[공사내역서(건축)]

마음건축소 조성사업
리모델링 실시계획 구역

NAME OF DRAWING : 018018
제작 가구 상세도

1층 평면도 (변경)
 축척 1/100 (50)

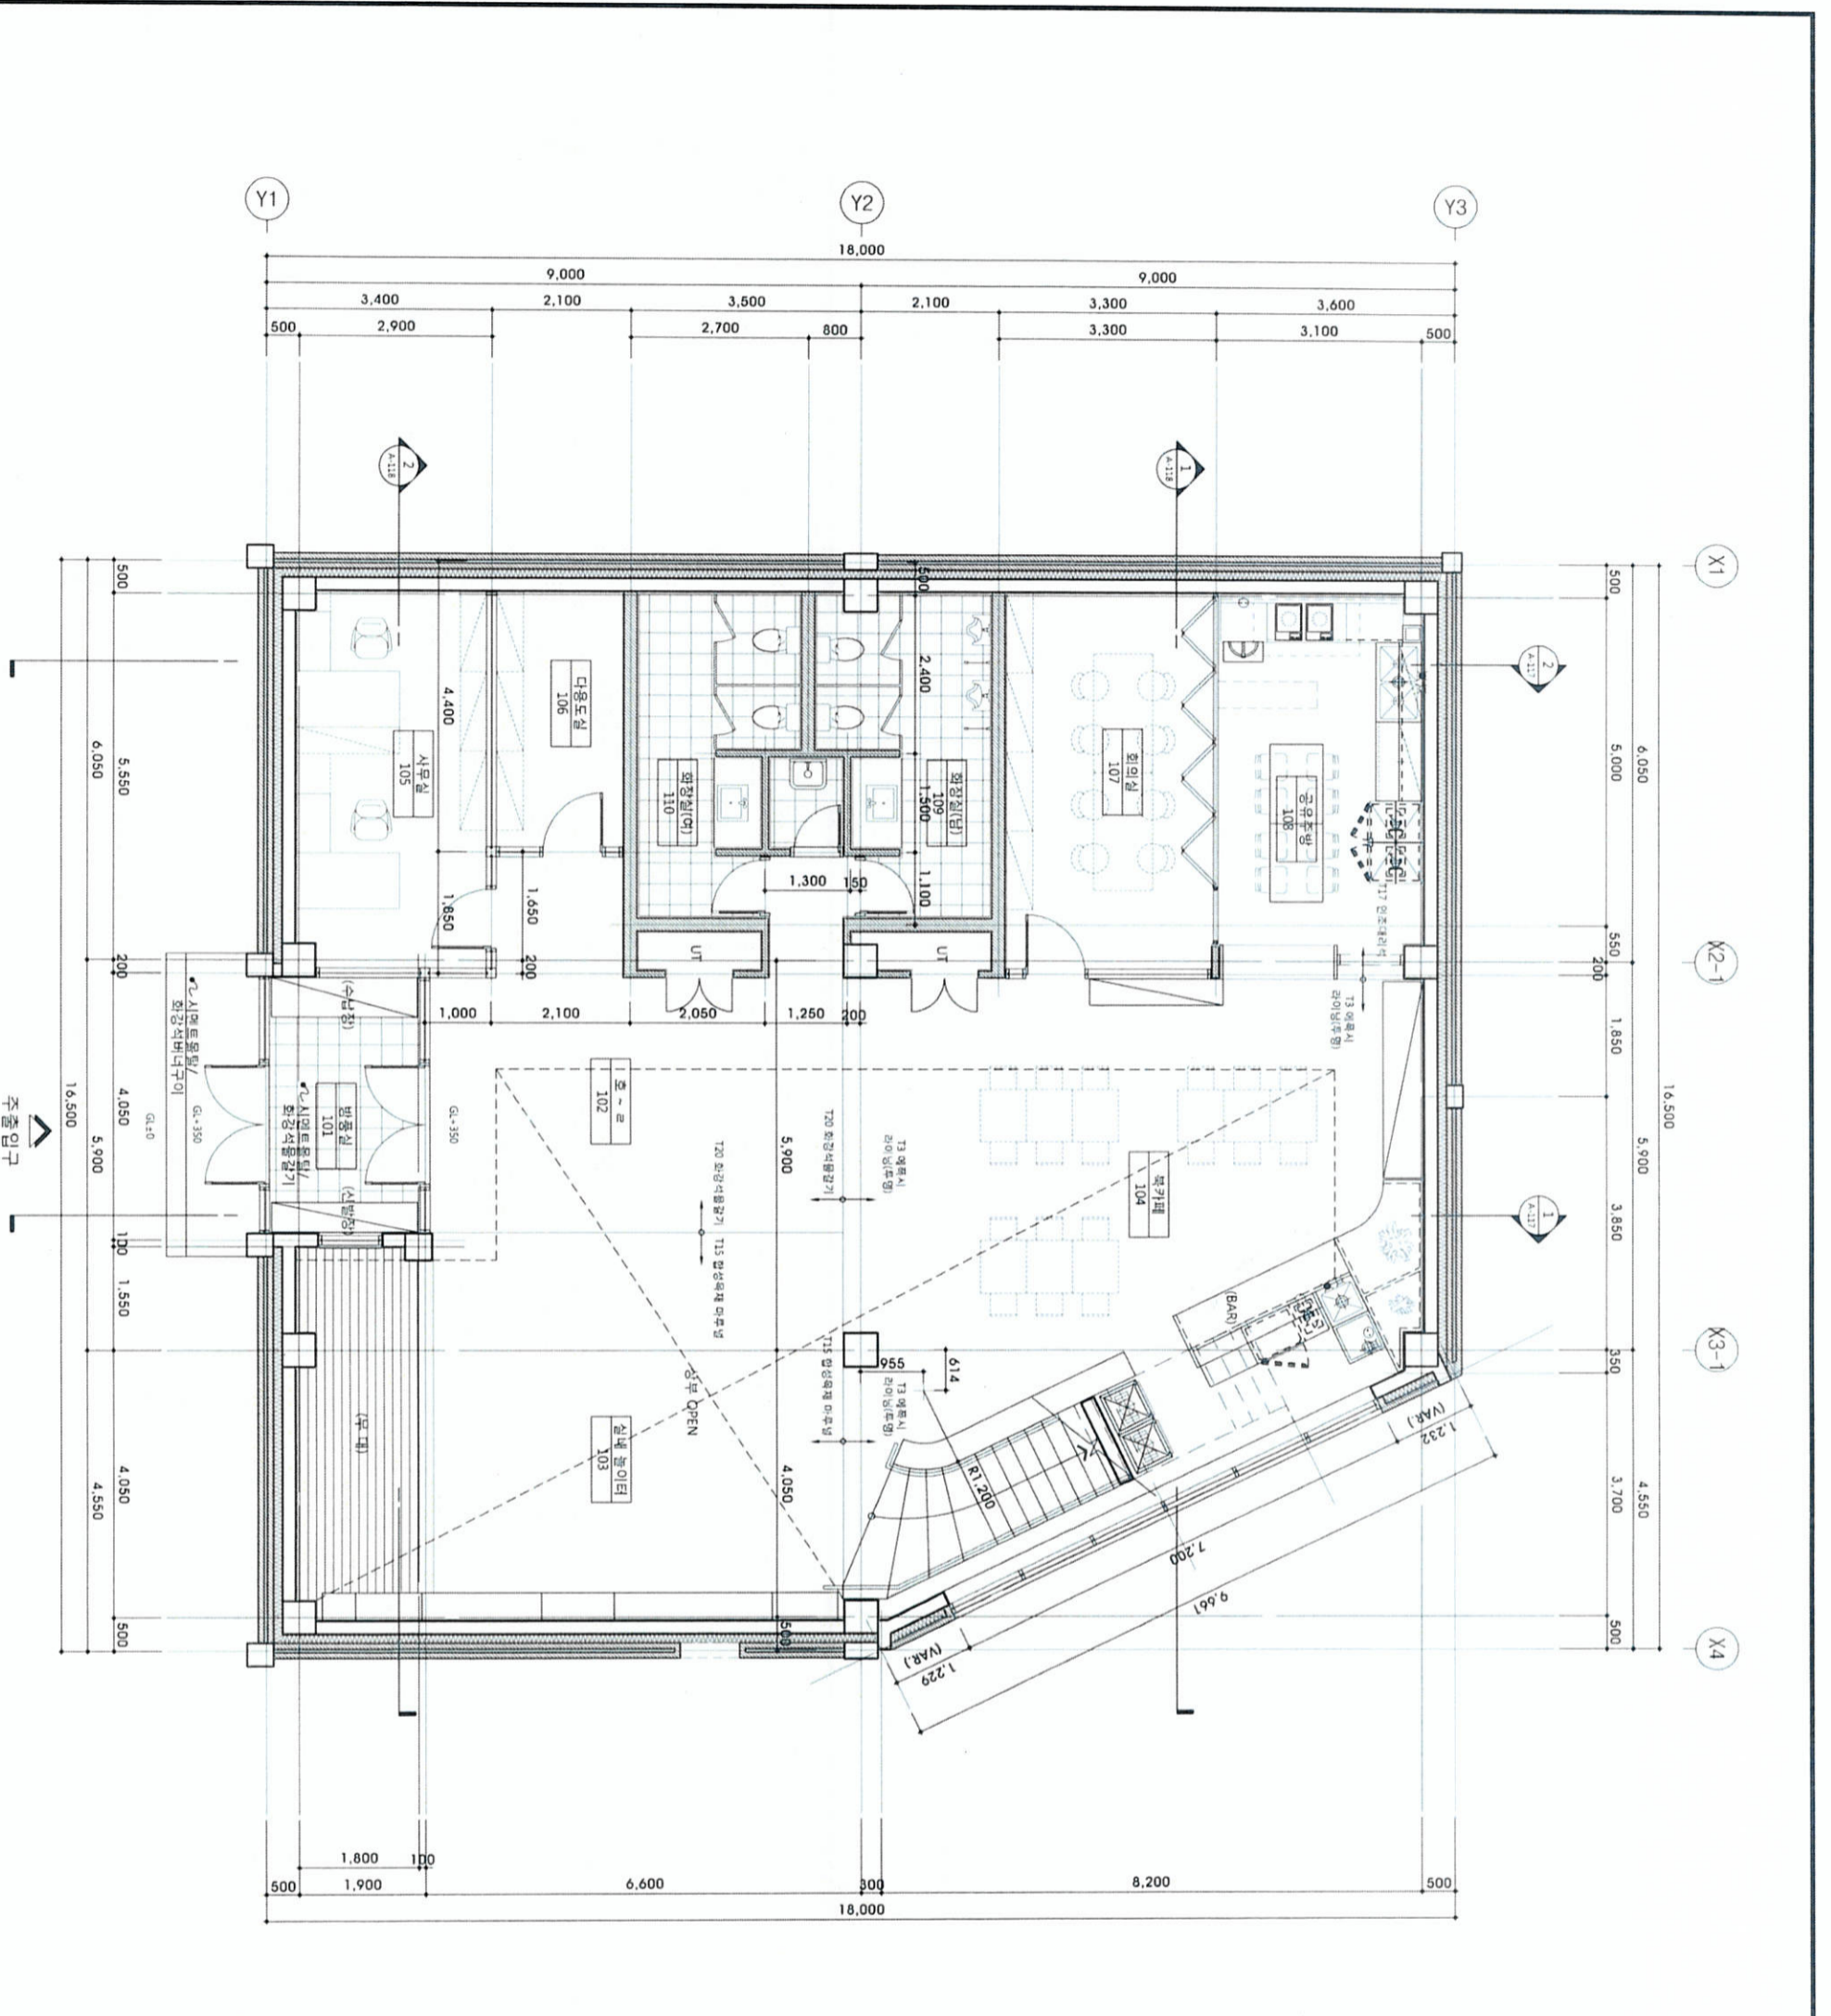
1층 평면도 (변경)
 DATE: 2021. 5
 SCALE: A1 : 1/ 50
 A3 : 1/ 100
 DRAWN BY: [인]
 DESIGNED BY: [인]
 CHECKED BY: [인]
 APPROVED BY: [인]
 DRAWING NO: [인]
 SHEET NO: [인]
